SUNDRY NOTICES AND REPORTS ON WELLS

Burch Keely Unit #68

Plug and Abandonment Procedure
10 Sept 09

RE: Plugging and Abandonment Procedure, Conditions of Approval

"After"
Unable to inject below
retention at 490'

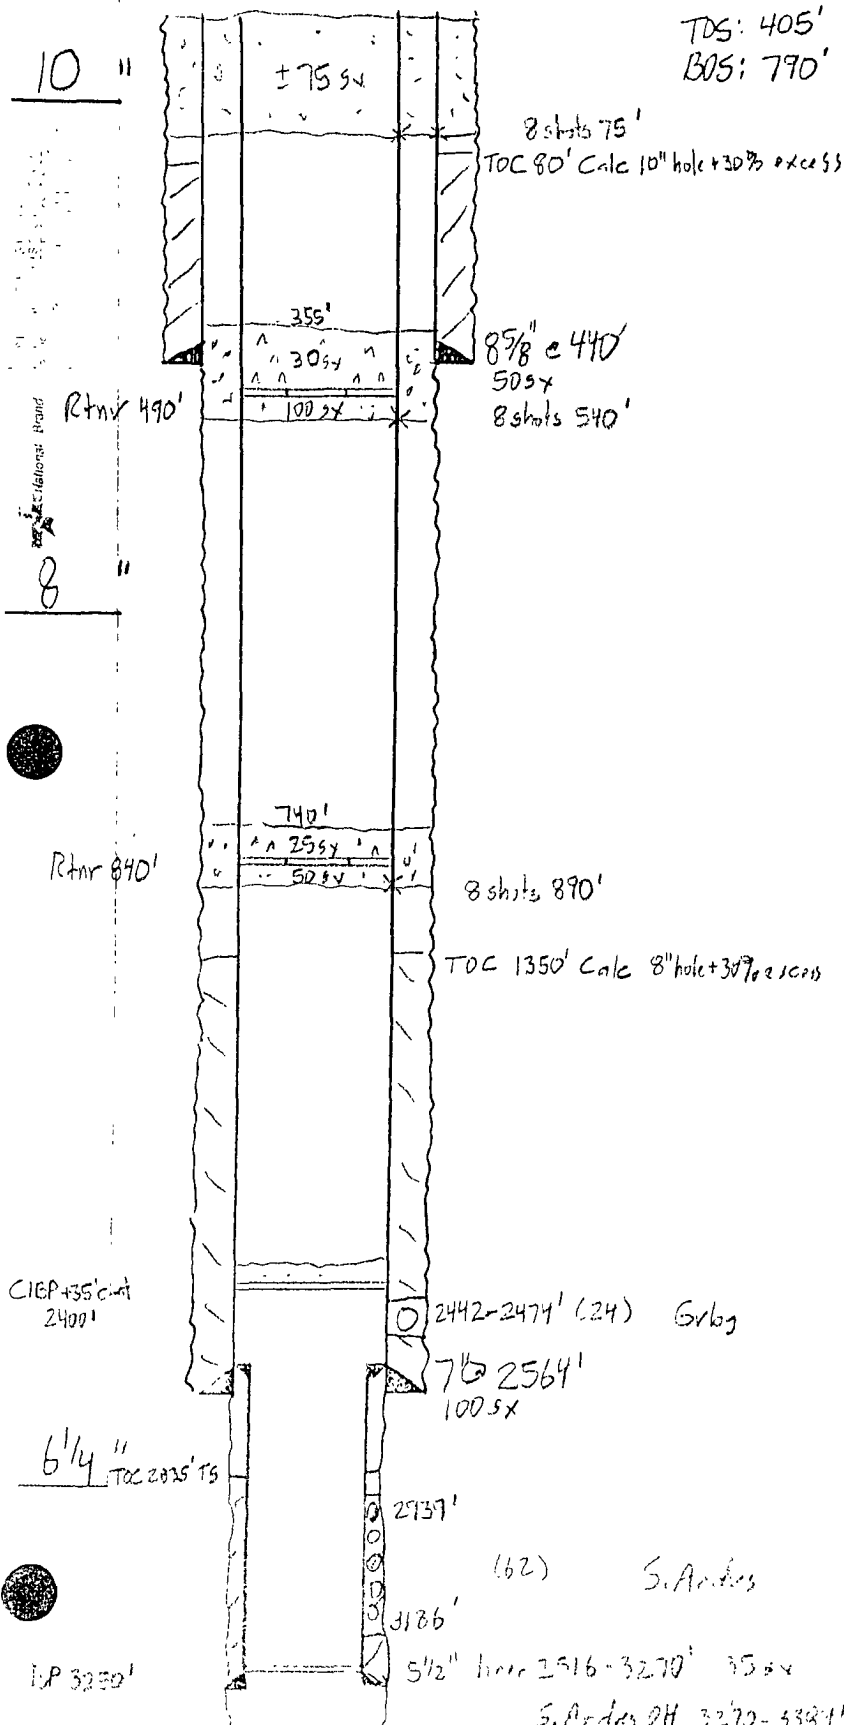
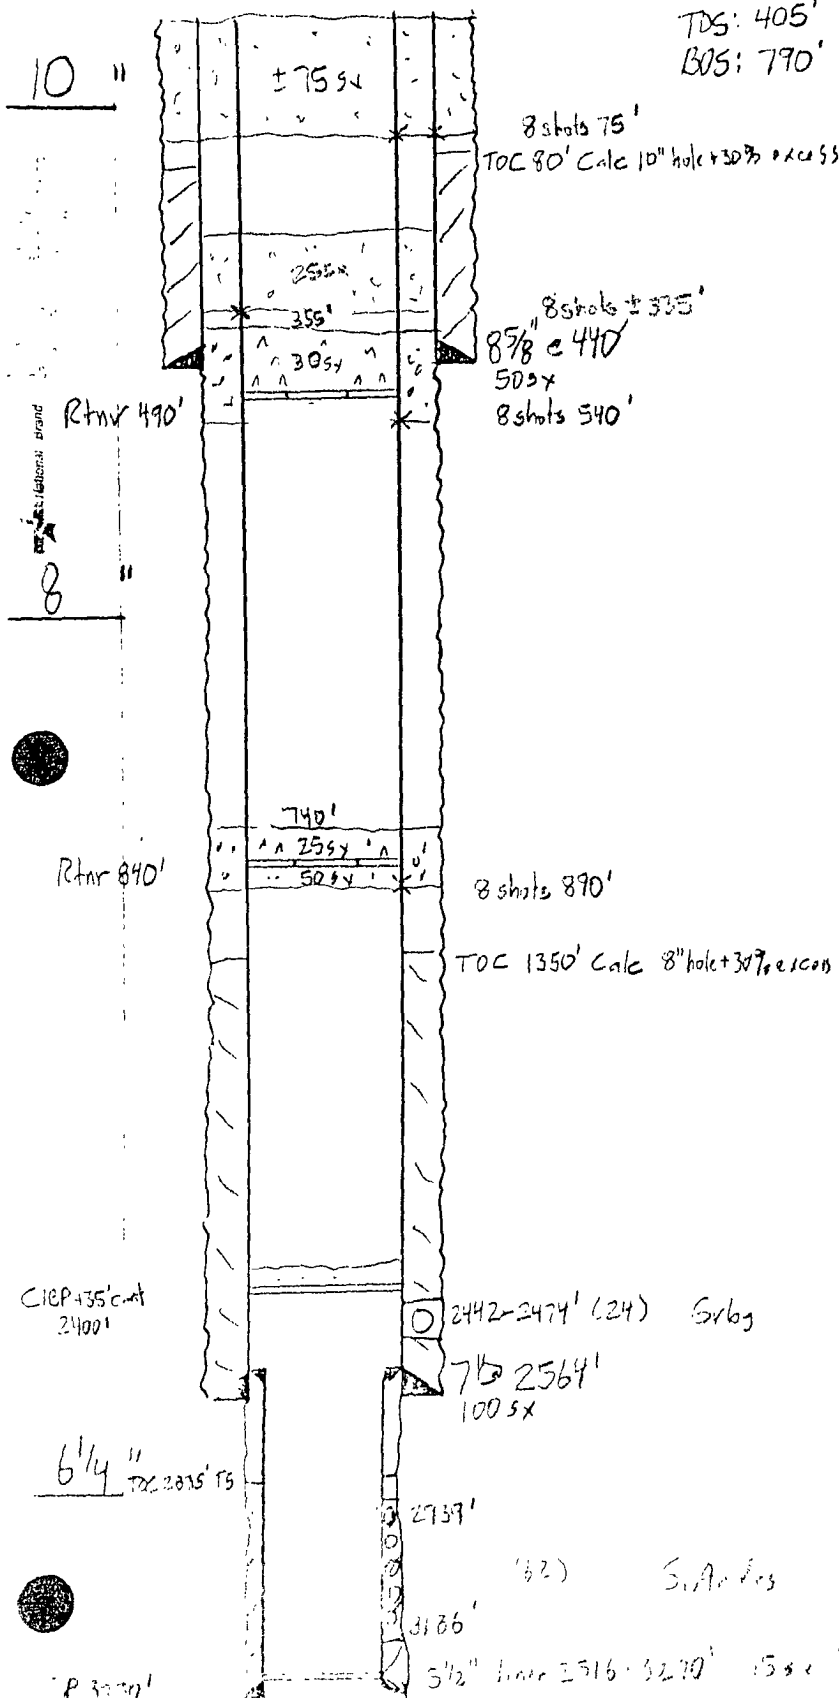
1. OK
2. OK
3. OK
4. Tag necessary due to base of salt – Otherwise OK (BOS)
5. Tag at 355' or shallower – Otherwise OK. If injection rate cannot be established, spot 25sx on top of retainer, WOC, tag and refer to 5a. (Casing shoe – TOS)
- 5a. If injection rate was not established on above plug, perf and squeeze 20' above the tagged depth. Plug is to be a minimum 100' and 25sx.
6. Verify that cement is to surface in all annuluses – Otherwise OK (Surface)
7. Submit subsequent report to BLM
